ORIGINATION FORM

Proposed Revisions to a Standard Plans Index
(Please provide all information — Incomplete forms will be returned)

Index Number: 700-110
Sheet Number (s): 1
Index Title: Mounting Exit Number Panels To Signs

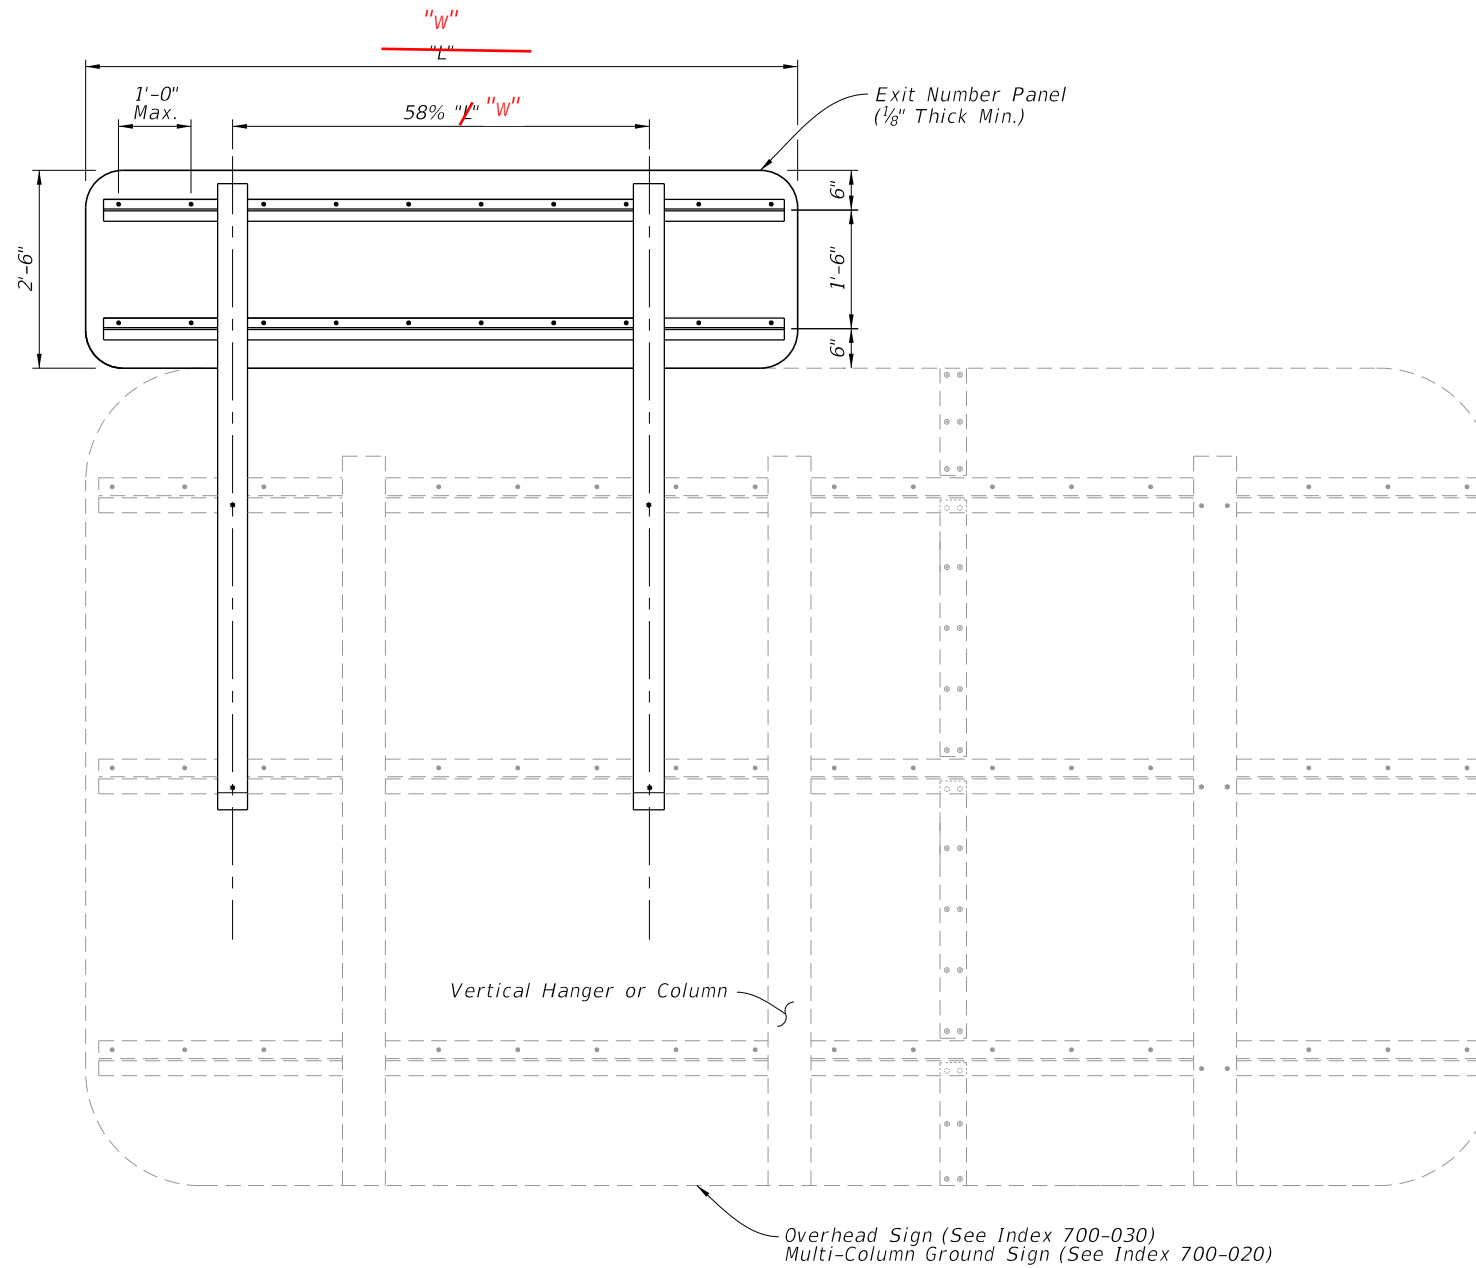
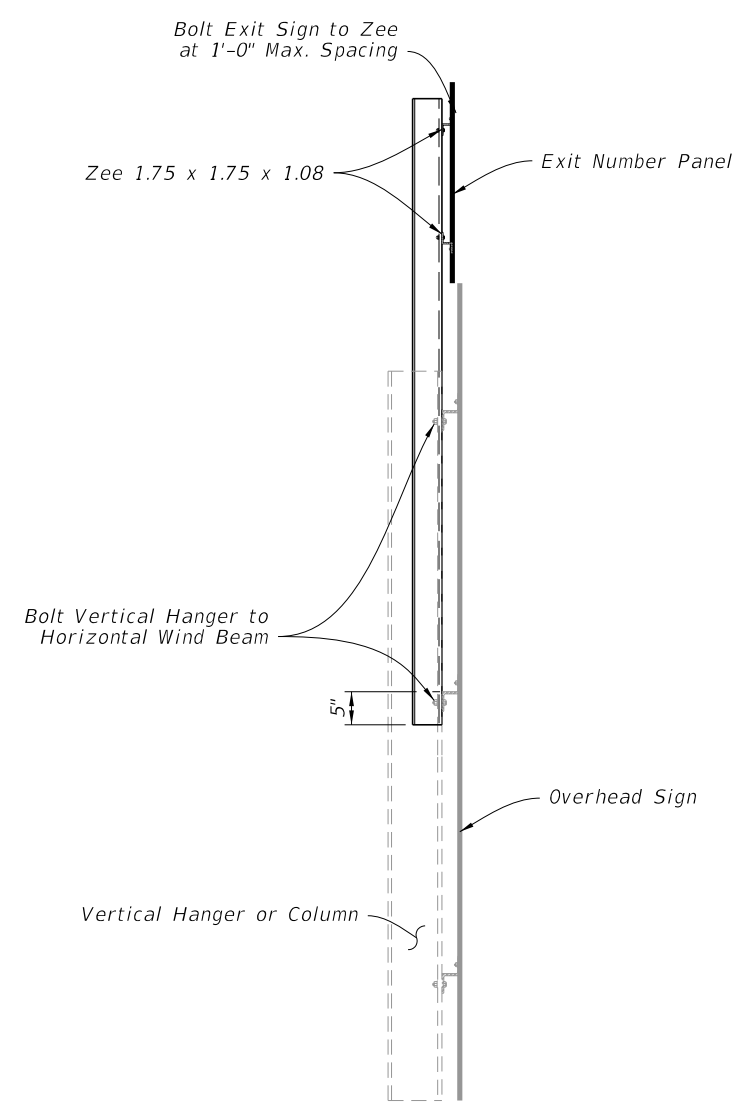
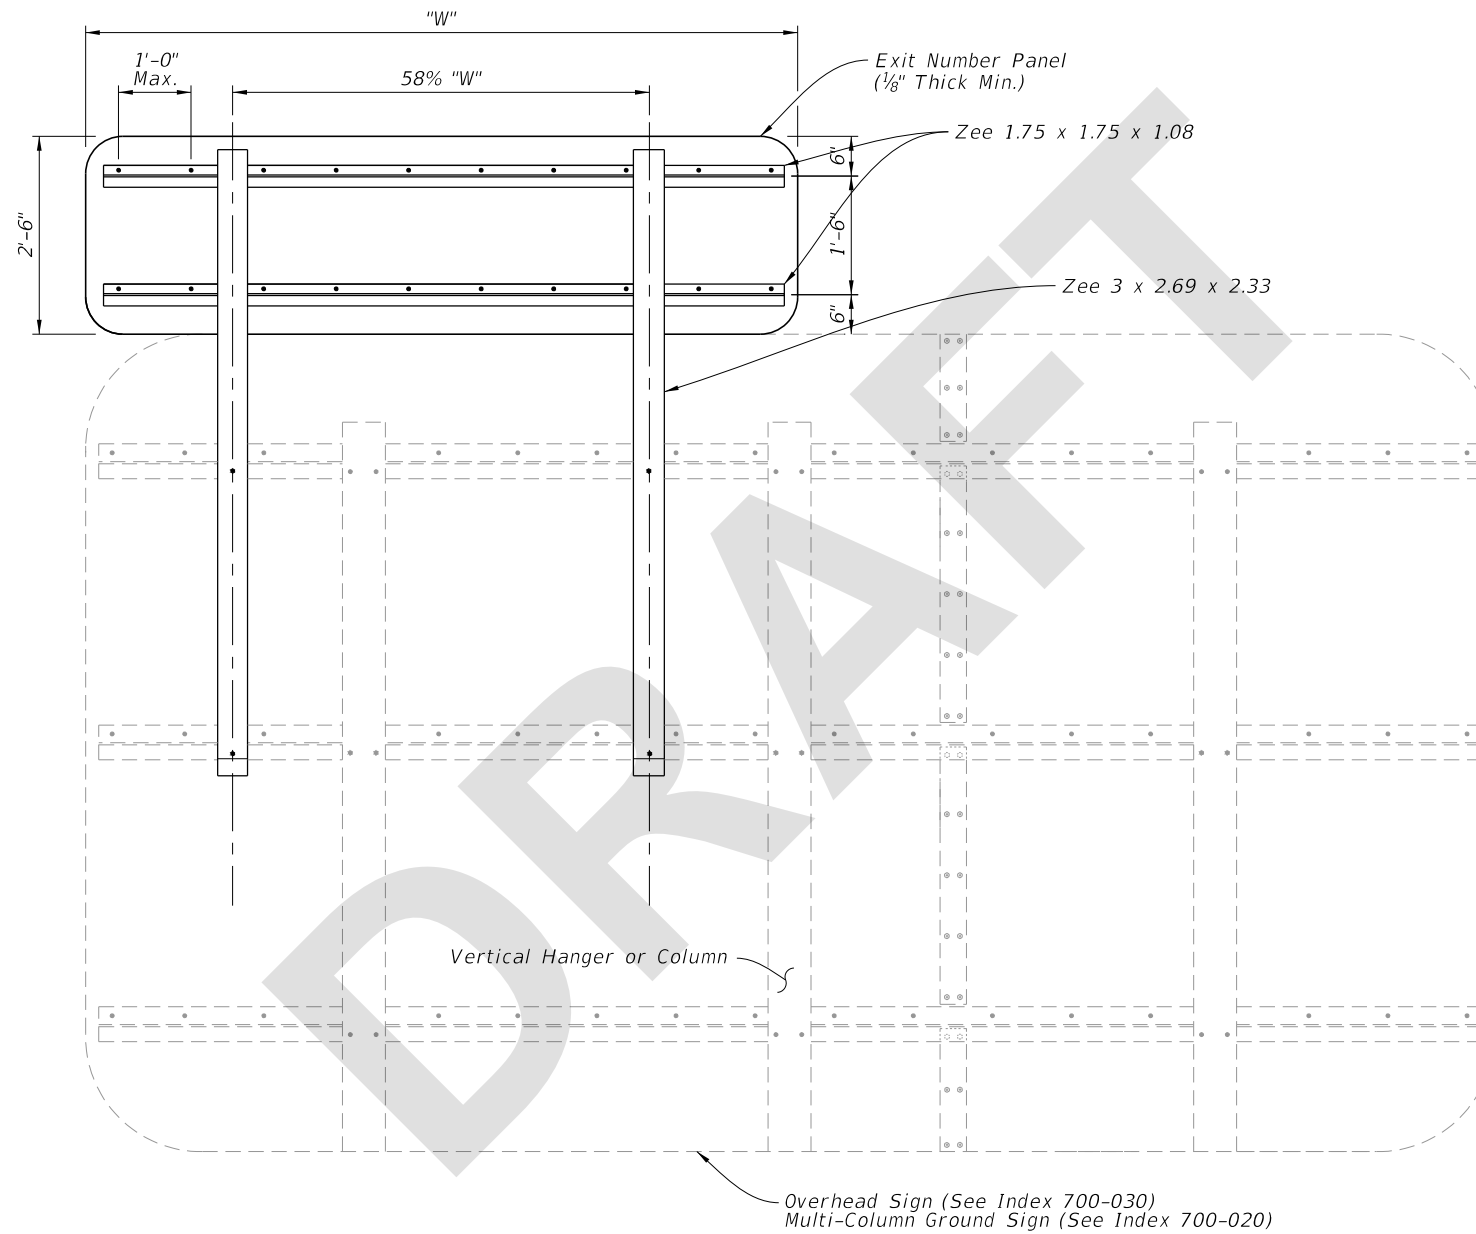
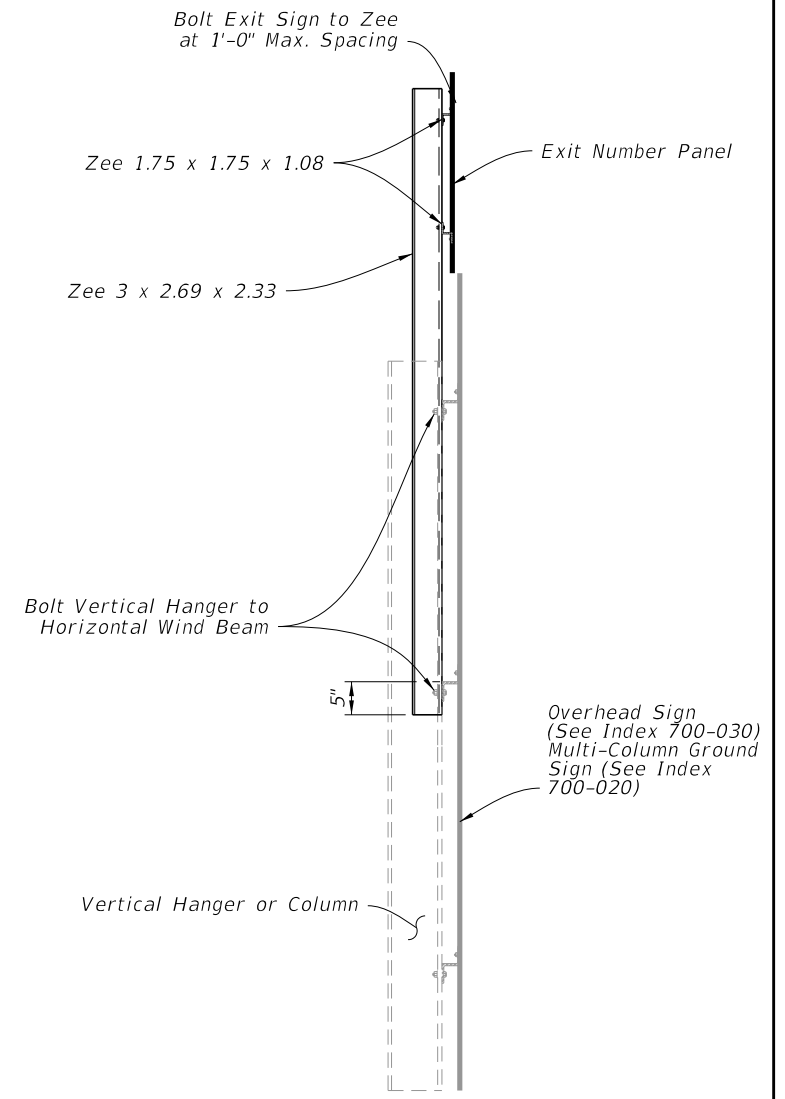
Changed all reference of length to width to keep consistent with MUTCD

The change is to be consistent with how the MUTCD dimensions signs. Section 700 and 995 will also need to be updated to be consistent with MUTCD.

1. Meet the requirements of Specification 700.
2. Work with Indexes 700-020 and 700-030.
3. Fabrication:
See sign layout sheet for dimension "W" and sign face details in the Plans.
4. For right exits, install the Exit Numbering Panel to the top right side of the Highway Sign.
5. For left exits, install the Exit Numbering Panel to the top left side of the Highway Sign.
